Memorandum

Dakota Springs Engineering

Subject: Waterview Final Plat
SF-16-017

This memorandum has been prepared to address the comments you provided concerning the Springs at Waterview Final Plat in your letter dated November 28, 2017. Your comments are provided below with our response comment immediately following in *italics*.

PROJECT: SPRINGS AT WATERVIEW
SHEET TITLE: NEW MOON - P&P
 FROM _____ TO _____ SHEET 9 OF 22

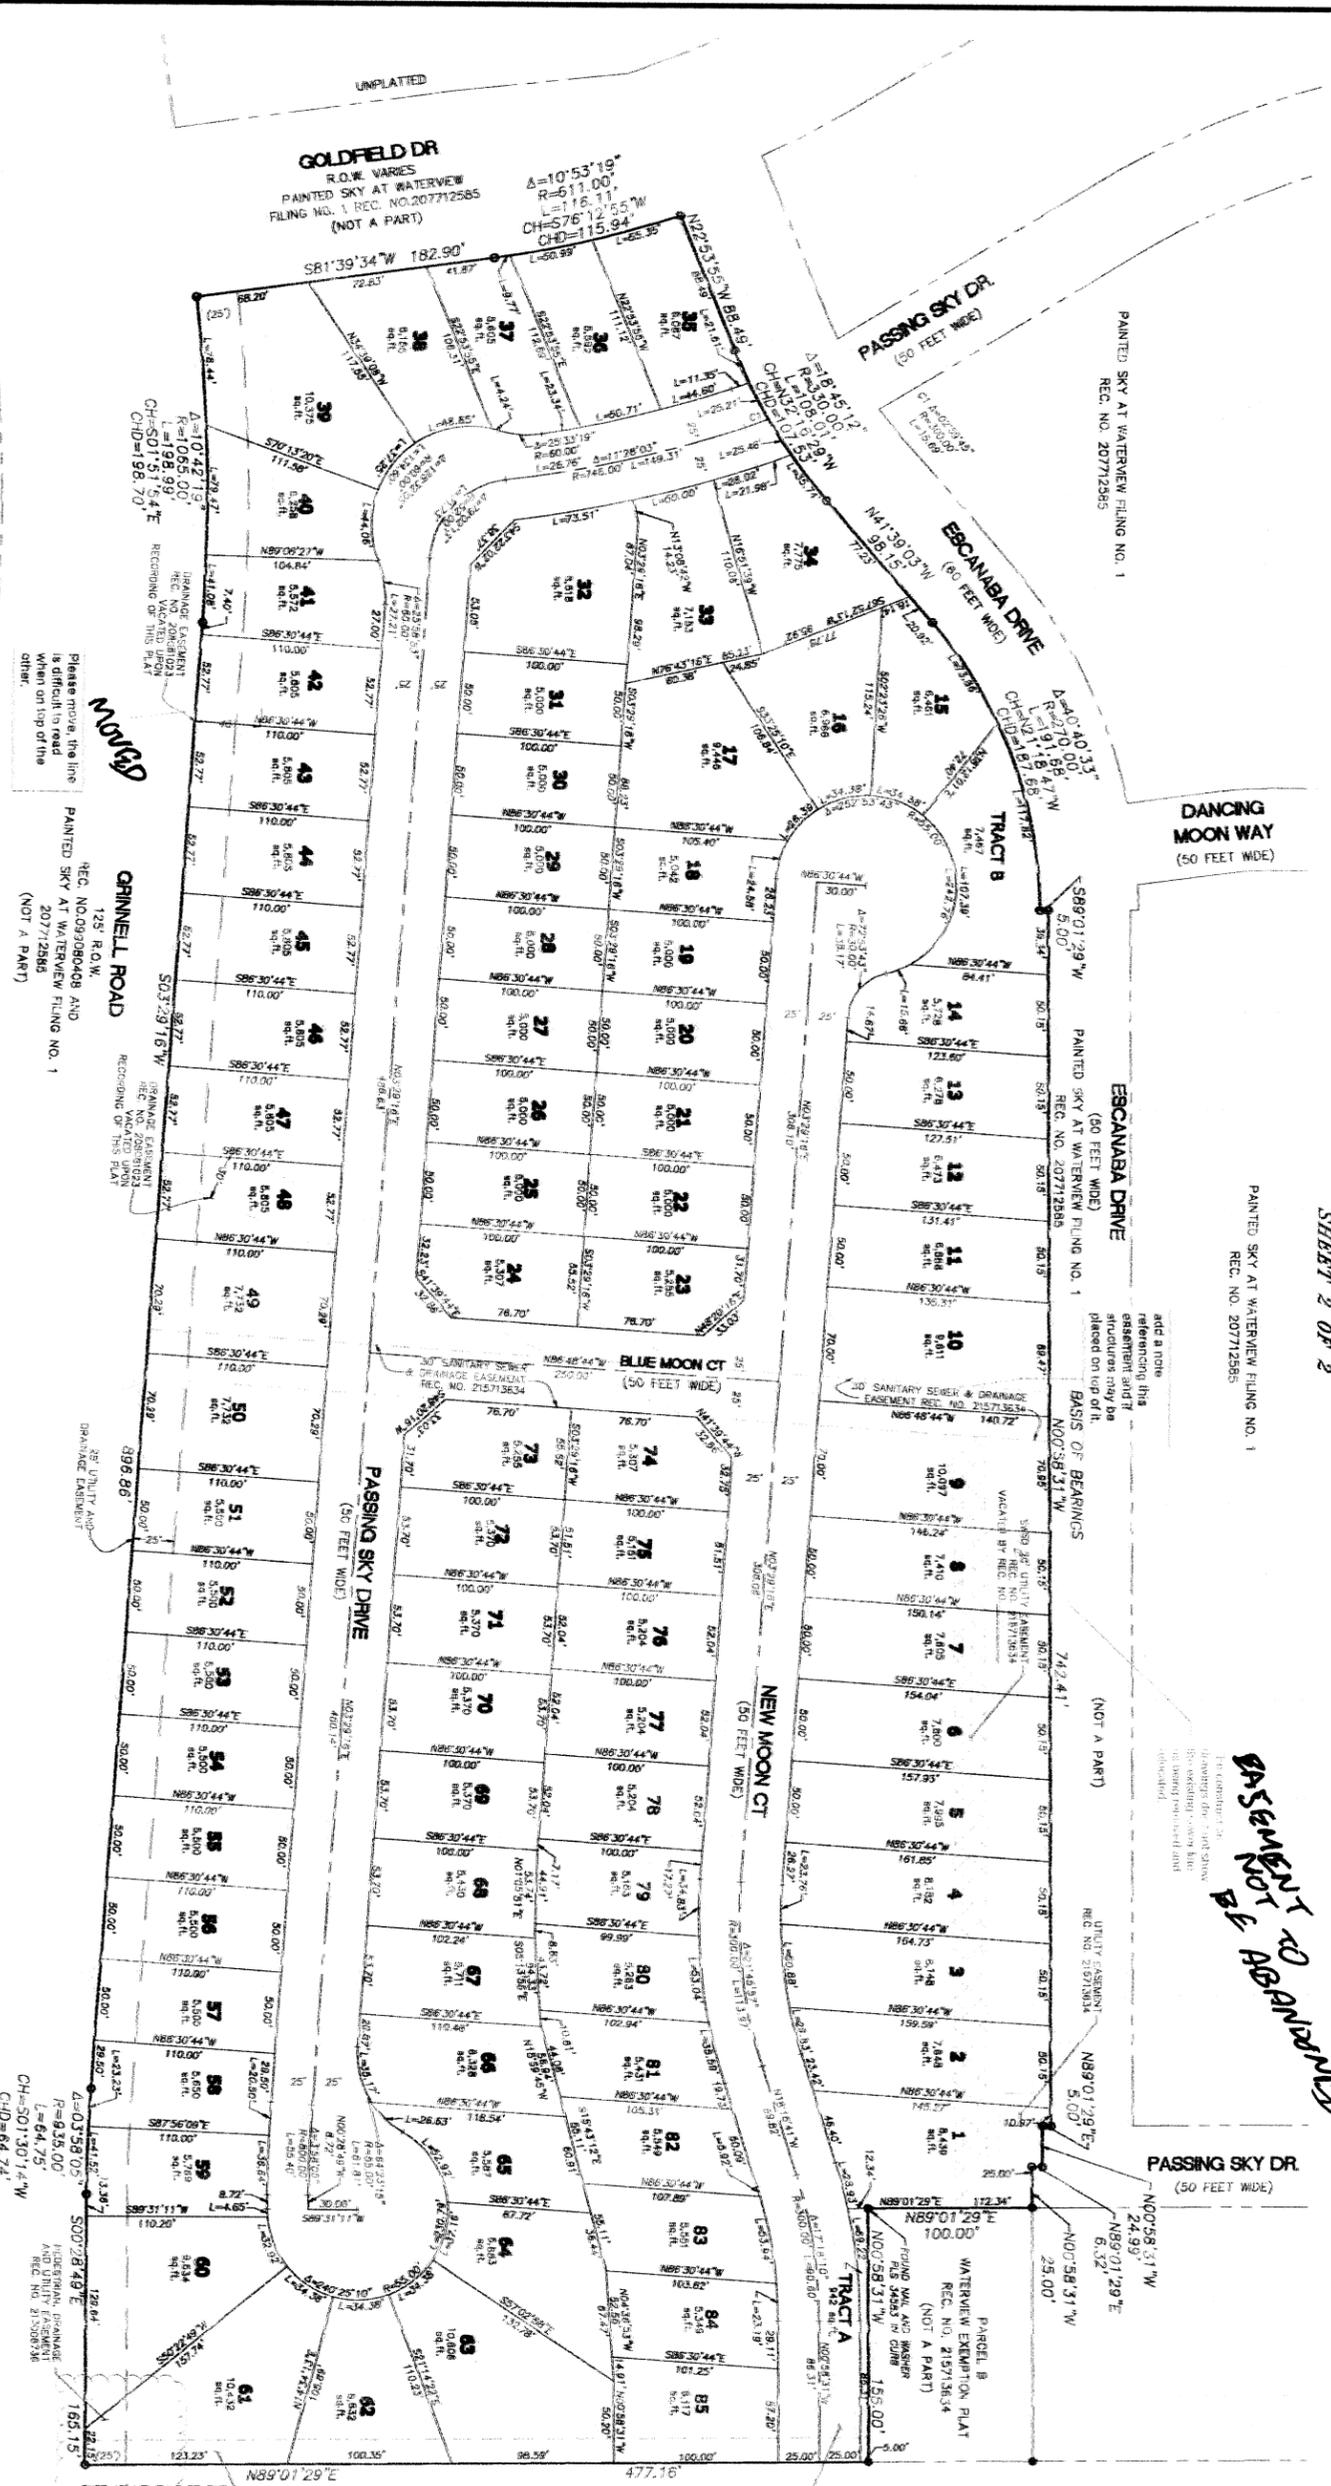
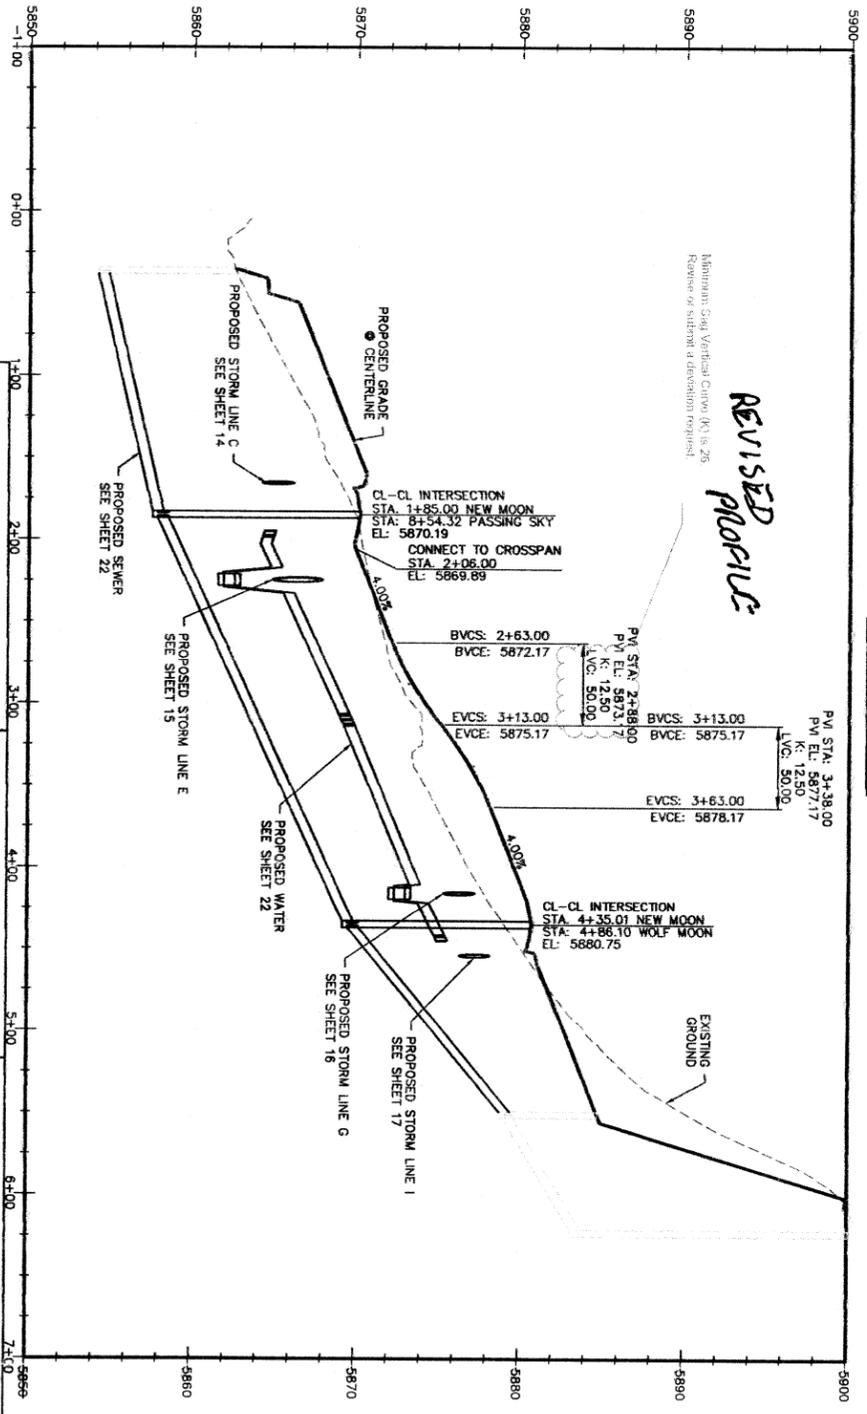
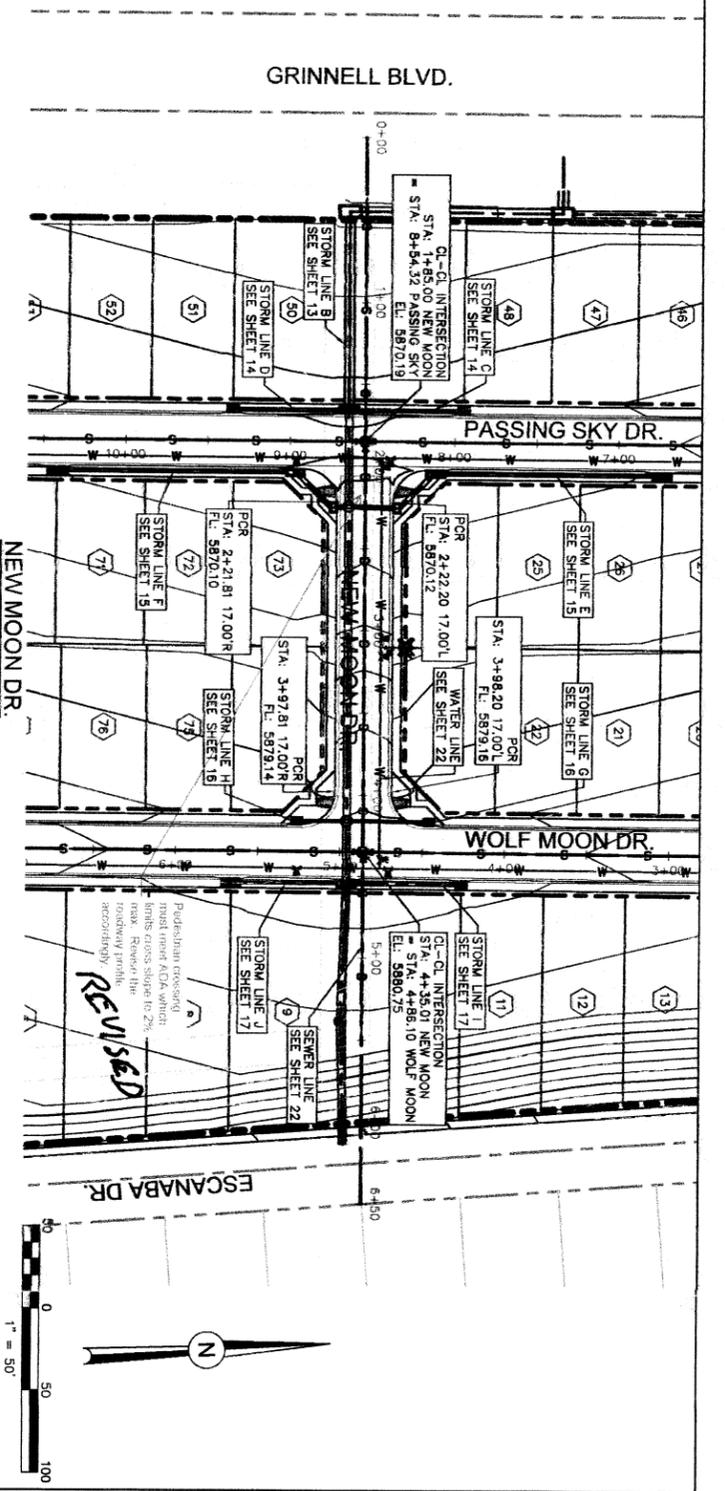
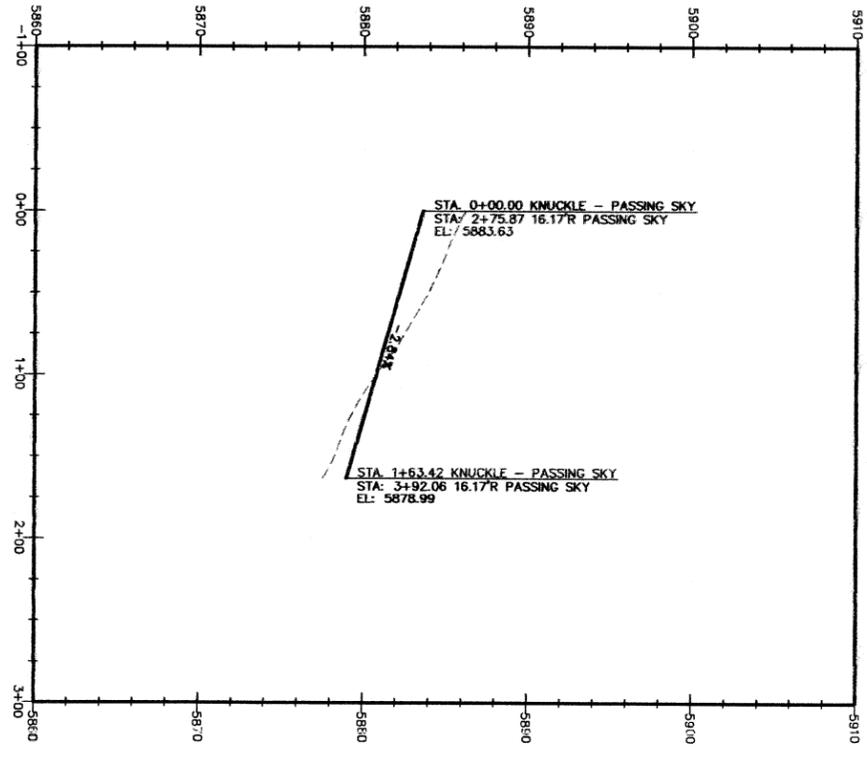
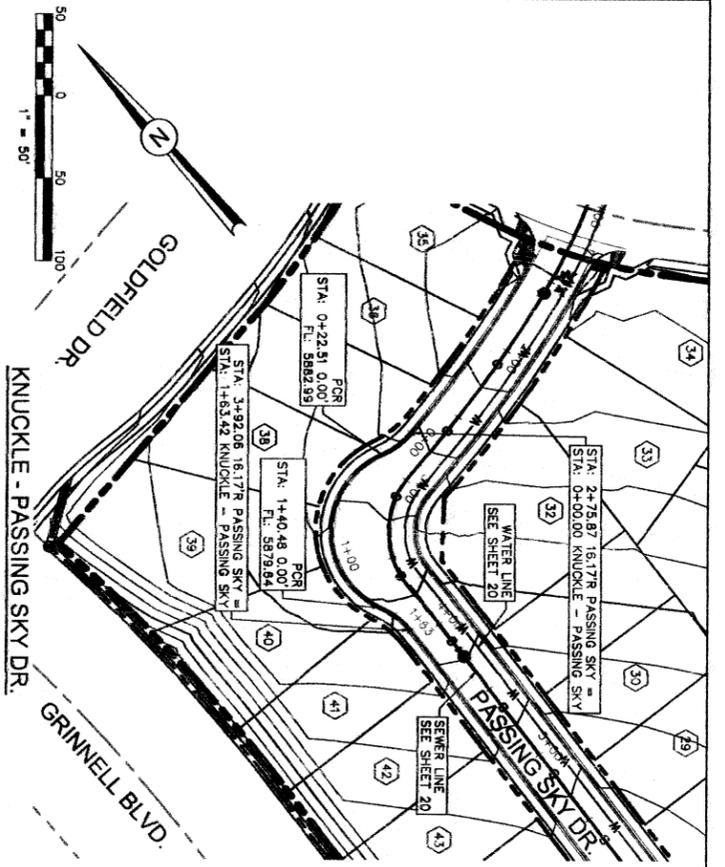
ADD setback line showing when lots are 50' in width for those that are not 50' at the boundary.
ADP

DSE Dakota Springs
 Engineering
 PROJECT SPRINGS AT WATERVIEW
 SHEET TITLE GRADING PLAN
 FROM _____ TO _____ SHEET 10 OF 22

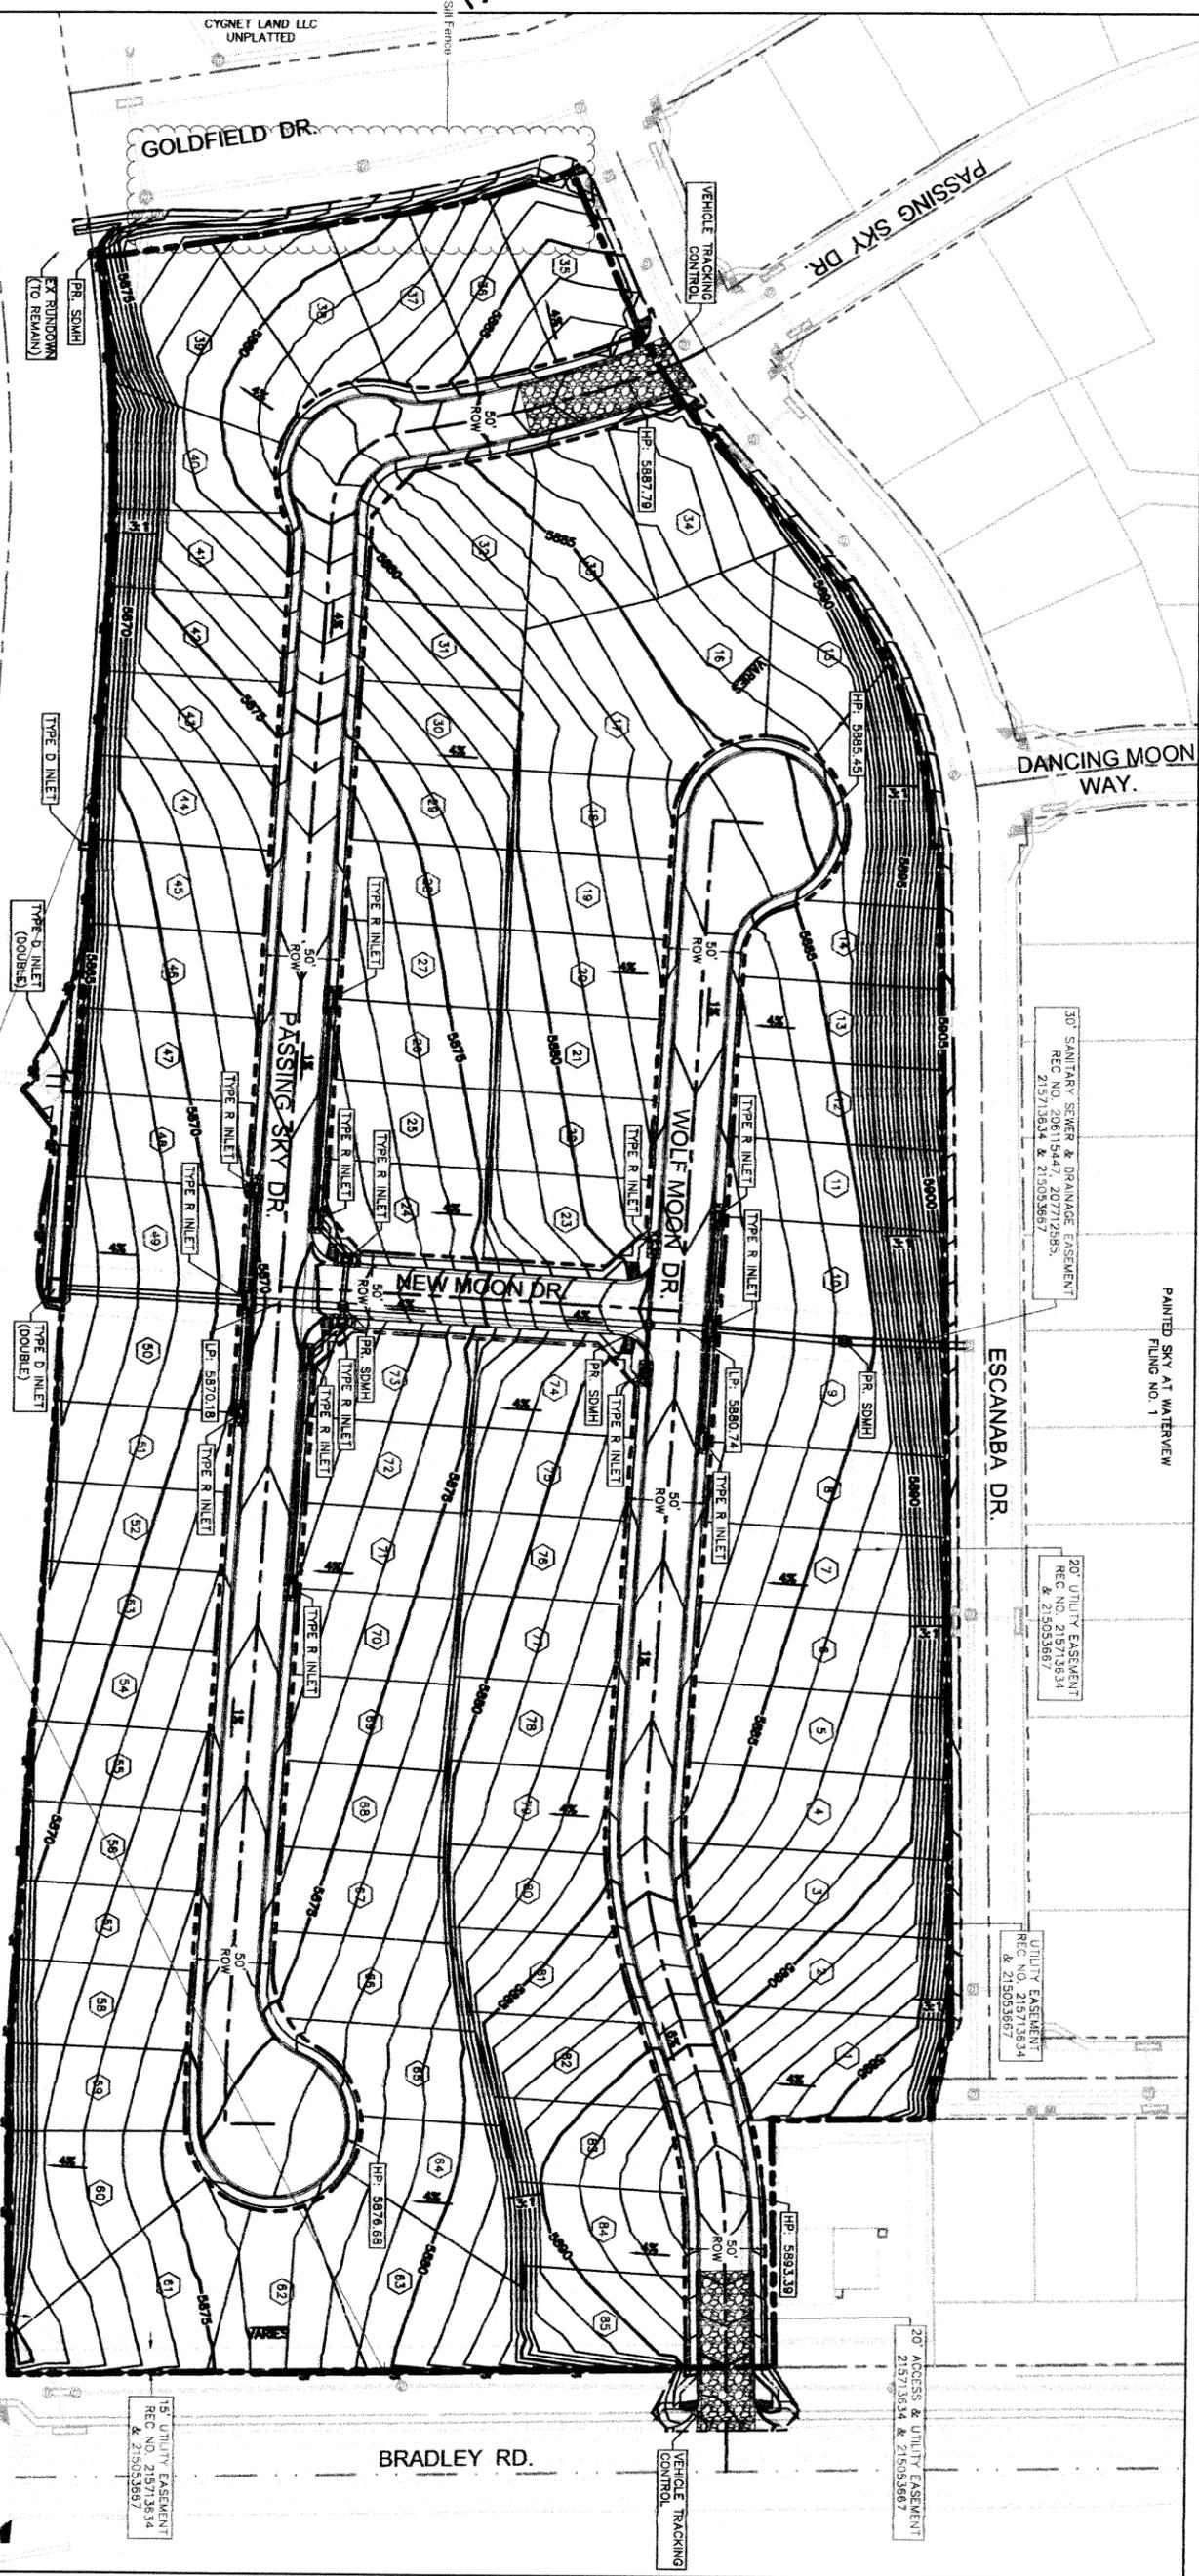
Per DCA Vol 2, temporary sediment basins are required in disturbed areas draining more than one acre. Provide a phasing schedule or Gentl chart of the installation/removal of the temporary BMPs.
